Amendments to the Drawings:

FIG.6

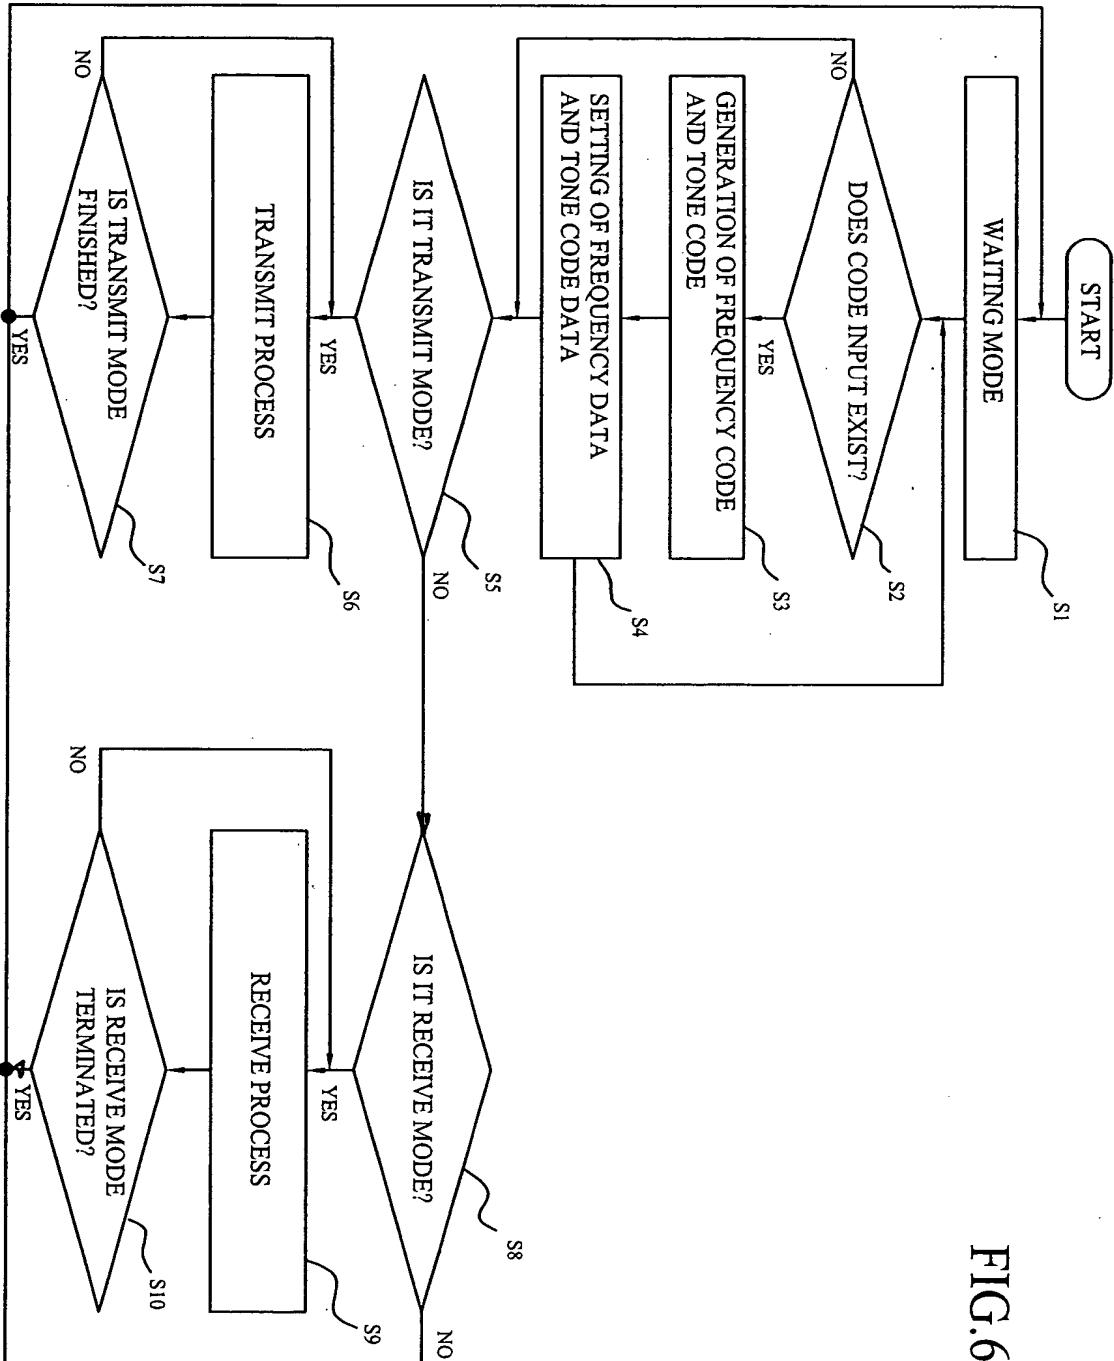
The Examiner's permission is requested to amend Figs. 1 and 6 as marked in red in the appendix of drawings hereto. With respect to Fig. 1, the labelling of functional blocks that refer to "portion" is requested to be replaced with standard functional labels and with respect to Fig. 6, signal flow arrows are being added in two places.
